REPLAT OF MESA VILLAGE SUBDIVISION SW1/4 SECTION 4, T1S, R1W, UTE MERIDIAN

REVIEW COMMENTS

FILE #RP-95-158

TITLE HEADING: Replat - Mesa Village Subdivision

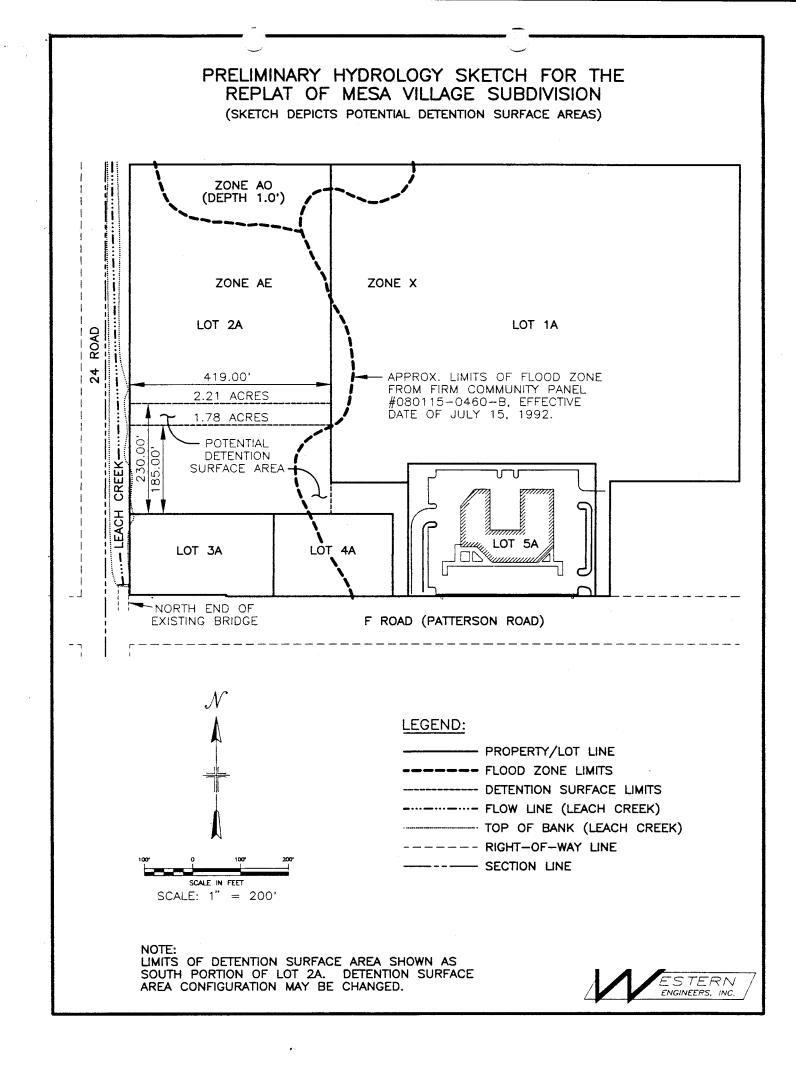
Also enclosed is a drawing showing a possible location for detention and the approximate limits of the detention area. I hope this has addressed the issues of concern. I know you had hoped to have this information sooner, but in order to do so I would have missed some tee times and would have needed to get to the office before noon. As it is I had to work on Friday to get this out. So lets try to be a little realistic and get our priorities straight, okay?

LEACH CREEK 100 YEAR FLOOD CALCULATED WATER SURFACE ELEVATIONS

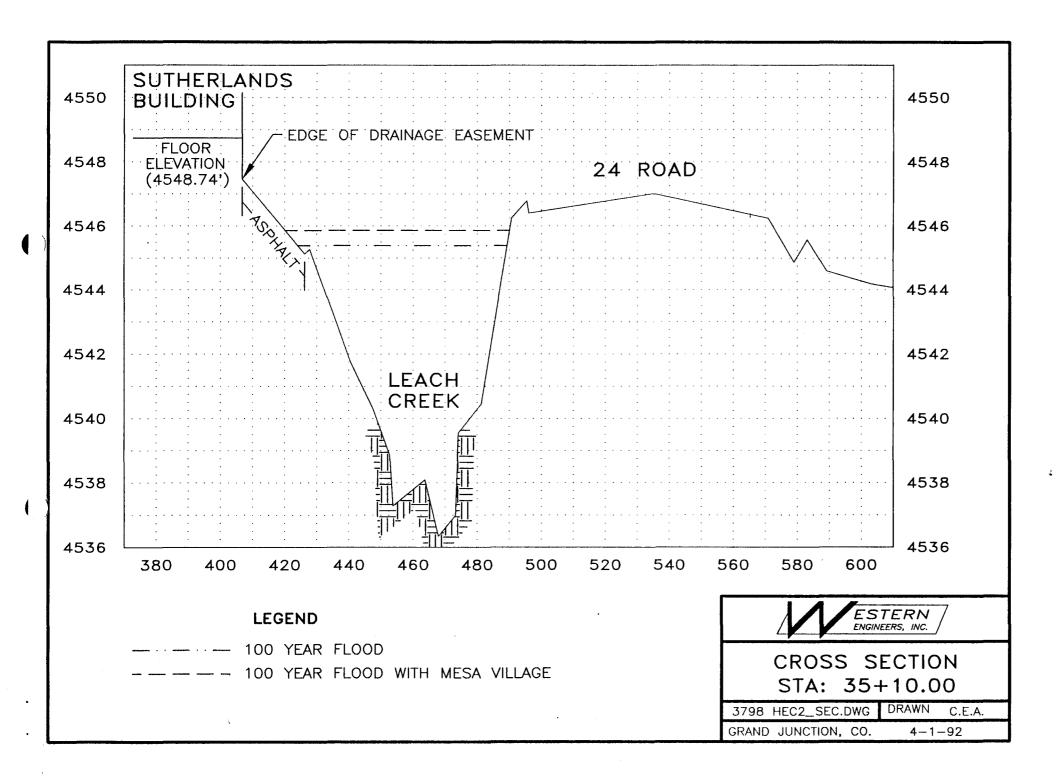
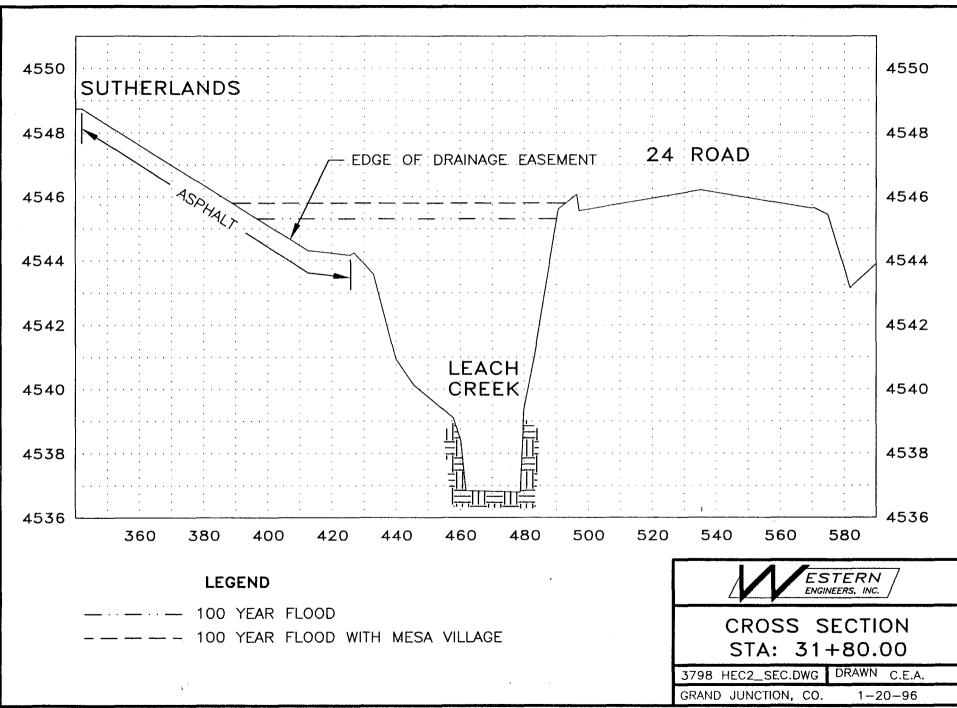
This is in response to concerns raised in a letter to you from Katherine Portner, the City of Grand Junction Planning Supervisor, concerning flood hydrology issues. Specifically, she requested that the developing of Mesa Village be evaluated regarding its potential effect on Leach Creek flood water levels in the vicinity of the existing Sutherlands Store. Following is a summary of this evaluation:

- 1. The addition of the estimated 100 year flood flows from the proposed Mesa Village development will raise the 100 year flood level in Leach Creek slightly less than 0.5 foot along the Sutherlands property.
- 2. On the North end of the Sutherlands building, the Leach Creek <u>100 Year flood water surface remains nearly 3 feet below the</u> building floor level and is laterally retained within the
